CITY OF VANCOUVER COMMUNITY SERVICES GROUP

DEVELOPMENT PERMIT STAFF COMMITTEE REPORT NOVEMBER 21, 2012

725 GRANVILLE STREET (COMPLETE APPLICATION) DE416152 - ZONE CD-1

Figure 1. Level of transparency at ground level in existing condition and proposed development

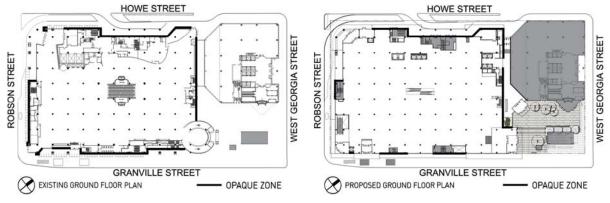
Transparency, Connectivity and Pedestrian Interest: Good active retail frontage should have maximum transparency into the building, provide for multiple entries along the store's frontage and support pedestrian interest. Maintaining the primacy of the street environment for pedestrian use, particularly where back of house operations come into play, is a key concern.

Generally, excellent grade level transparency has been achieved along the Granville and Robson Streets. This is less so on the Georgia frontage and no improvements have been made along Howe Street in this regard. (To compare existing conditions to what is proposed please refer to drawings in Figure 1). Staff would recommend further consideration for additional pedestrian entries, much greater transparency including display windows/cases along Howe Street and elsewhere where solid walls are proposed. These concerns are covered under Design Condition 1.2.

- design development to improve transparency, connectivity and pedestrian interest at street level in the following manner:
 - 1.2.1 provide for clear glazed doors and windows along the Howe Street façade and opportunities for window displays where solid wall conditions occur at street level;

Note to Applicant: Provide opportunities for pedestrian connections and interest along Howe Street, reconciling the internal retail requirements with an excellent public realm. Maintain retail continuity and pedestrian interest at

grade providing window displays where solid wall conditions occur. Provide details.

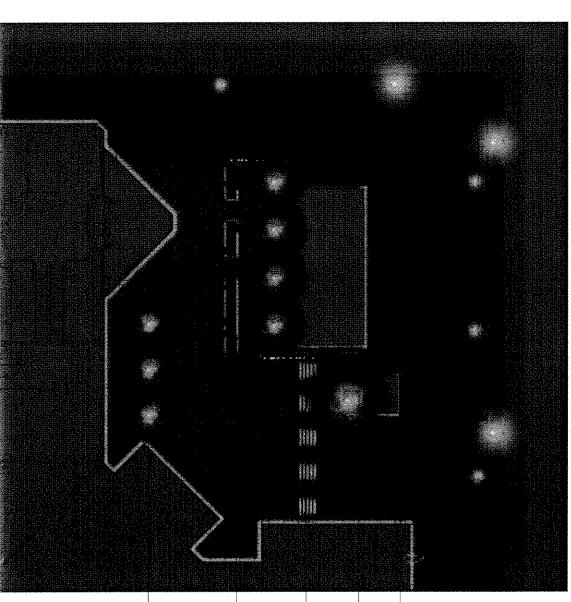
Note to Applicant: The planting depth for the single specimen tree beside the Canada Line elevator should be illustrated on Section 4. The depth of the soil for the trees grown in an open planter shown on Section B should be increased from two to three feet in depth. The slab underneath this open planter and the specimen tree should be illustrated on the sections.
